EXHIBIT G-3
LU 14-0031

PROJECT: 314126-Master Plan Review for ILU 14_0031 (The Highlands) **SUBJECT:** Summary of Storm Drainage Master Plan Peer Review and Comments

TO: Gary Willihnganz
Forest Heights Neighborhood Association (FHNA) **FROM:** Josh Lighthipe, PE
KPF Consulting Engineers

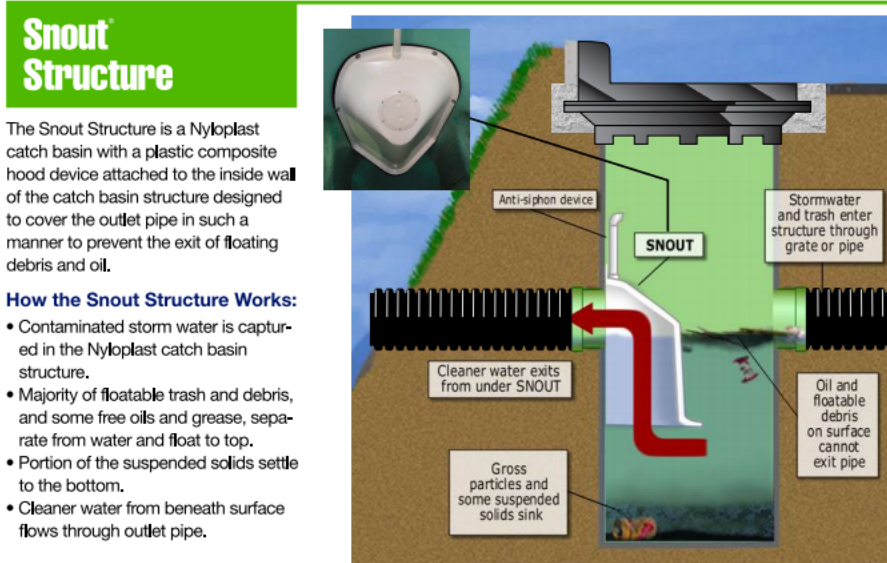
- 2.1 In addition to the sump, the sedimentation manhole should also contain a sediment trap, ideally using a Snout® type product to minimize downstream discharge of sediment and debris, and to ensure that maintenance can be easily performed by City crews. See image of Snout® product within a similar drainage structure below.

EXHIBIT A: Downstream Drainage Areas of Concern

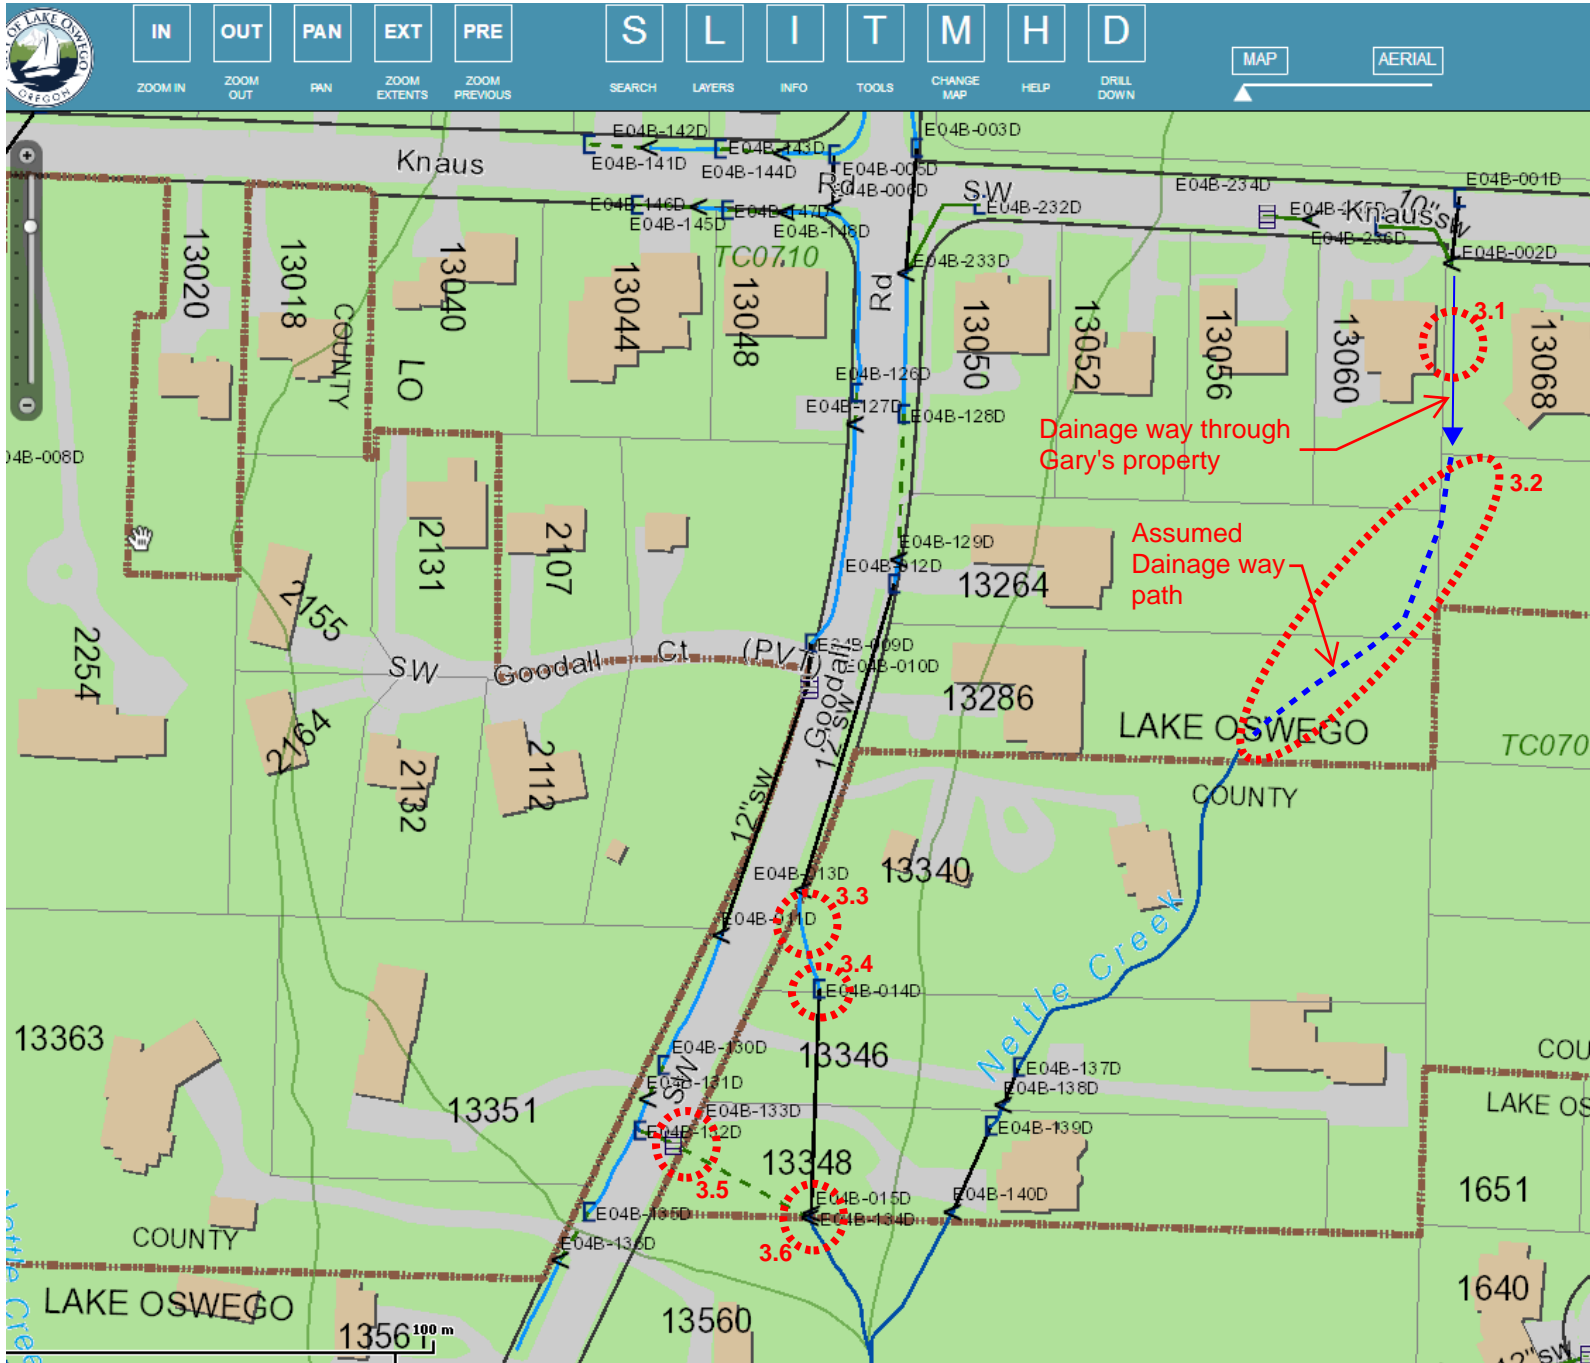
Based on a site walk through the neighborhood with Gary Willihnganz following the June 19, 2014, meeting, several areas of concern along the downstream drainage ways and ditches were noted. The following are the issues and recommendations for each of the areas of concern observed. Refer to the attached Exhibit A for their locations and Exhibit B for some photos of them.

- 3.2 This portion of the drainage way is not managed by the City of Lake Oswego or anyone as far as we know. The flow connection to Nettle Creek indicated on the Exhibit A was assumed, but from the topography it appears likely.

Area 3.3 - Culvert outfall to an undefined channel with evidence of erosion

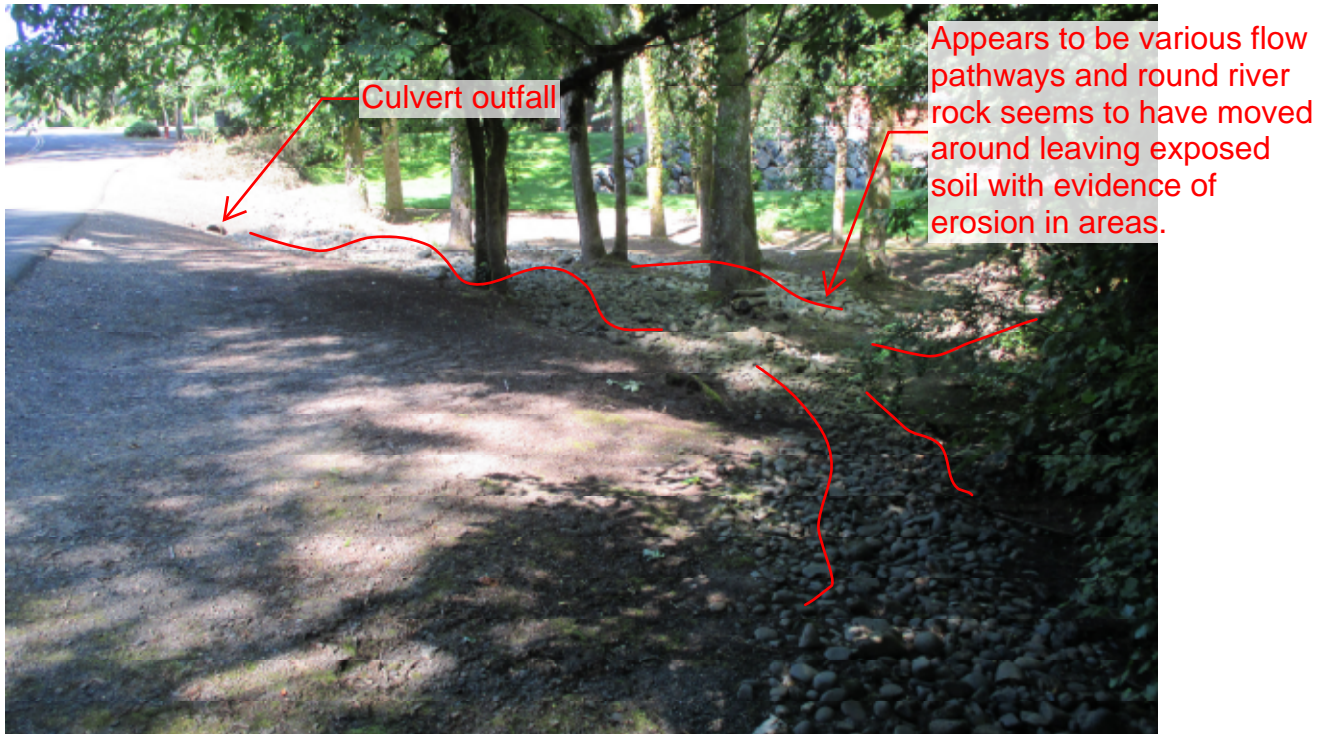
- 3.3 This is the point at which street runoff and all upstream drainage discharges out of pipe outfall and flows across bare ground and beyond the street right-of-way. Round river rock appears to have been placed to slow runoff, but has migrated and significant signs of erosion are apparent throughout area.

Recommendation: Construct defined drainage channel with adequate rip-rap rock armoring and check dams if needed to prevent scouring that connects the drainage flow to the culvert opening (Area 3.4).

Area 3.4 - Upstream end of culvert through private property appears semi-clogged

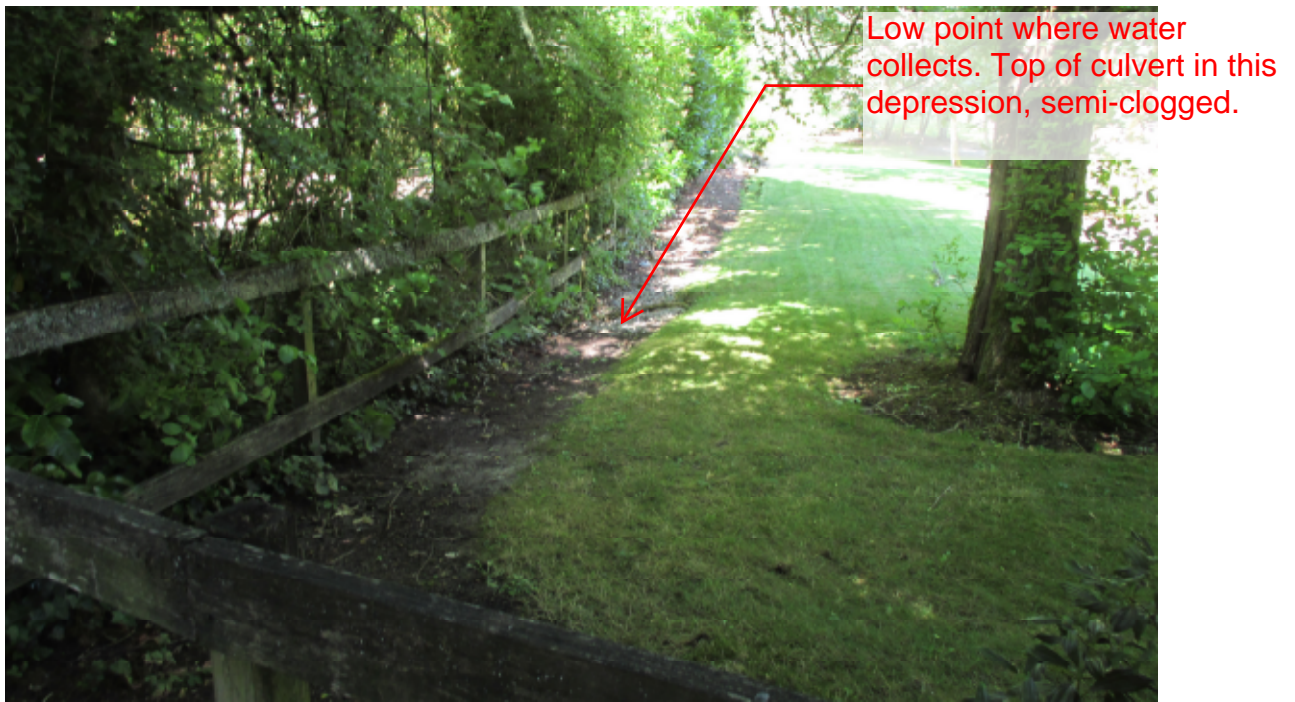
- 3.4 Surface drainage enters culvert here. Culvert appears semi-plugged.

Recommendation: Install ditch inlet type of structure over culvert opening to limit potential clogging.

Area 3.5 - Roadway runoff missing CB

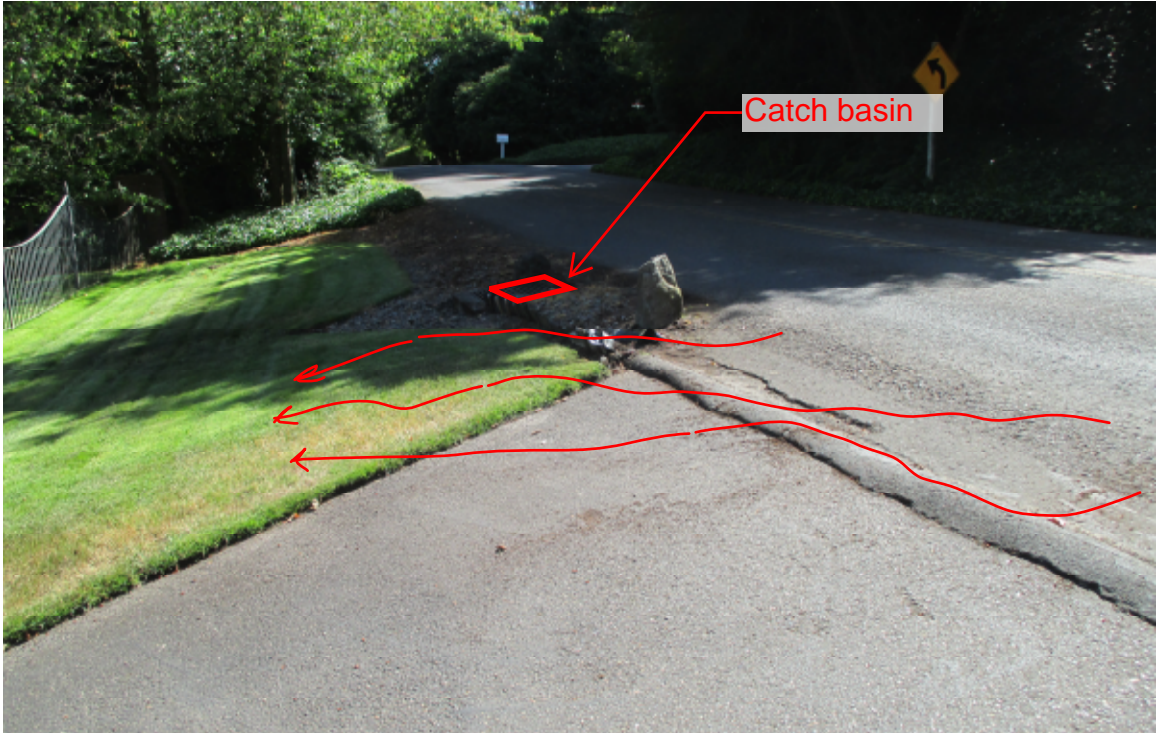
- 3.5 Drainage flows off roadway and misses street catch basin. It appears a neighbor tried to fix this by installing a short fence berm to redirect flows to catch basin.

Recommendation: Construct a more permanent and effective solution for this area to collect street runoff and convey it to the catch basin.

Area 3.6 - Outfalls into concrete trough with significant erosion downstream

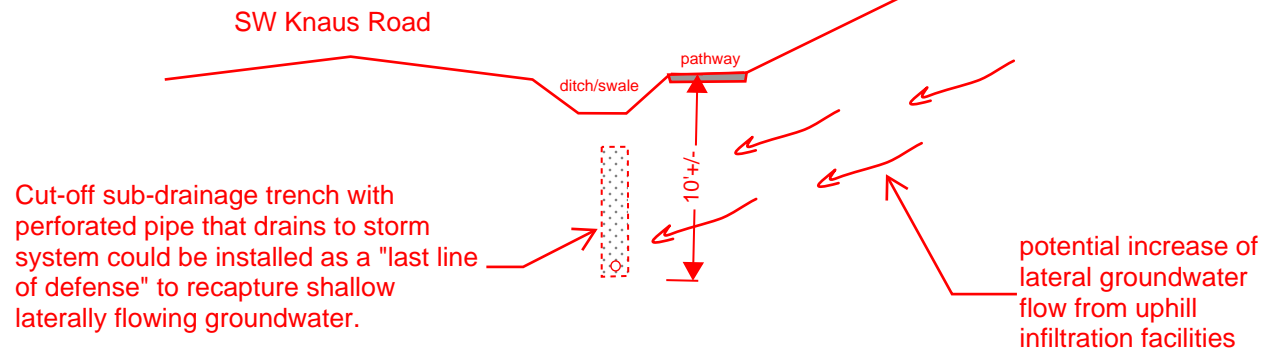
- 3.6 Multiple culverts outfall here into concrete trough. Downstream of trough, significant signs of erosion are visible.

Recommendation: This area should be protected with appropriate amount of rip-rap to prevent further downstream erosion.

EXHIBIT C: Cut-off Trench Strategy to Protect Downhill Properties

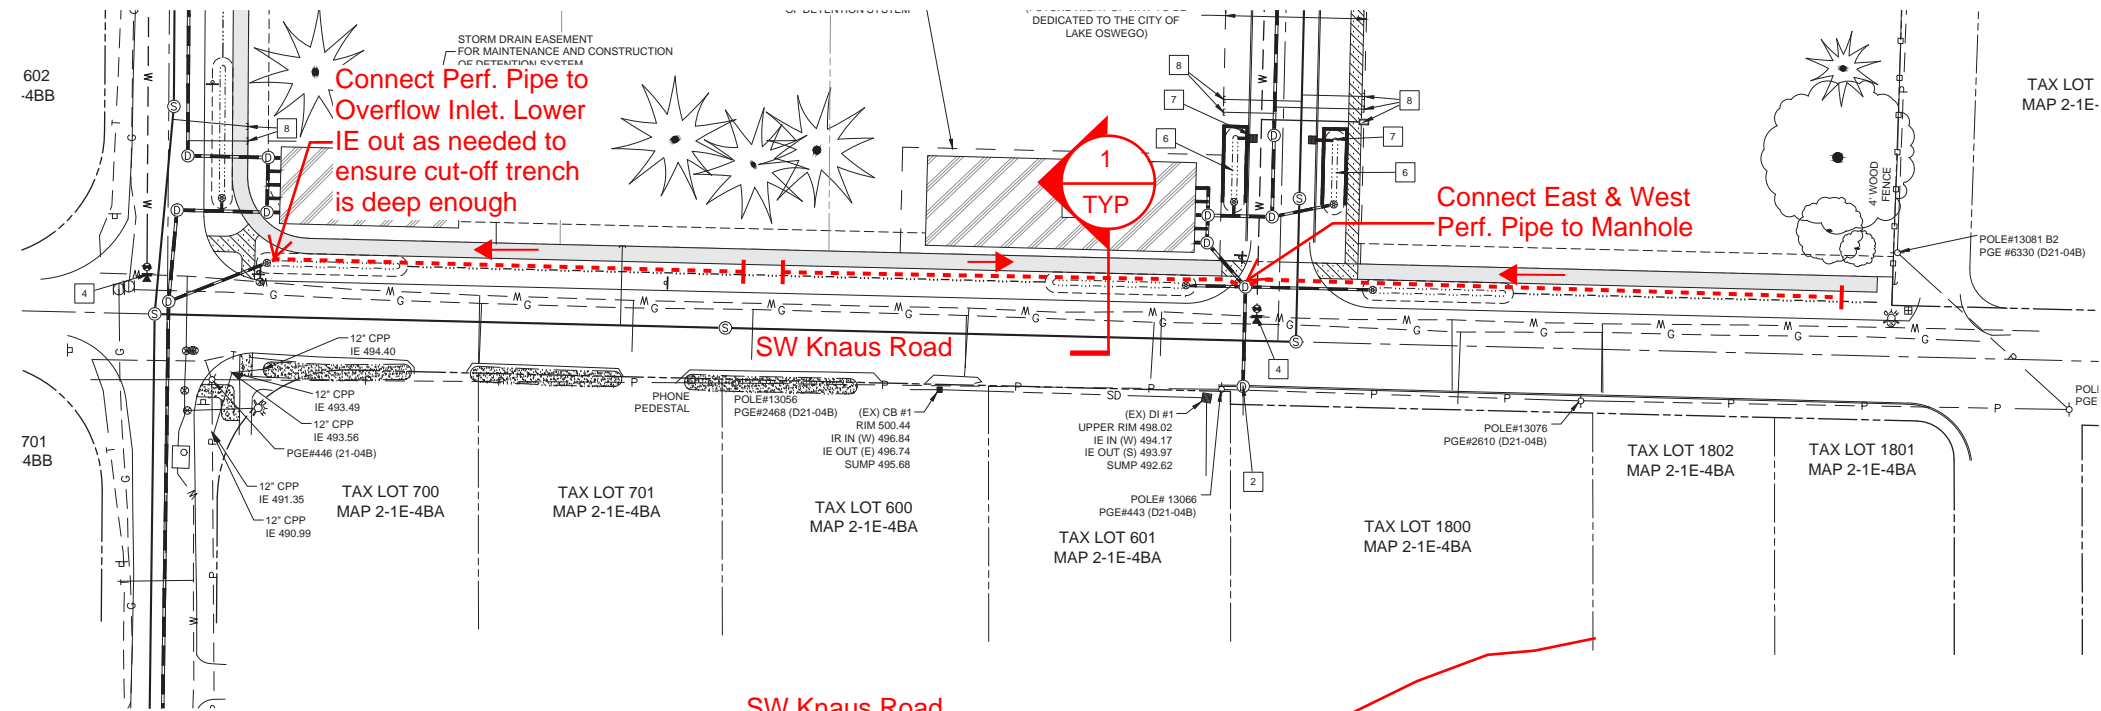
- 1.4.6. As a “final line of defense” strategy, which may be more effective than the previously mentioned recommendations for limiting lateral groundwater flow offsite, install a continuous subdrainage cut-off trench beneath the SW Knaus Road north ditch/swale line. The cut-off trench would be designed similar to a perimeter foundation drain, and composed of a drainage fabric lined trench with a perforated drain pipe at the bottom that slopes to drain at 0.5% minimum to the storm system. The trench would be backfilled with an open graded drainage rock and would extend up to 18-inches below the top of ground within the swale. The trench depth should be installed as deep as possible to intercept as much lateral flowing groundwater as possible, yet shallow enough to gravity drain to the storm system. There should be 2 separate cut-off trenches roughly positioned to capture lateral sub-surface runoff from each of the existing east and west basins, and drain to their respective discharge points. Refer to attached Exhibit C for a sketch of where this cut-off trench should be located and what it might look like.
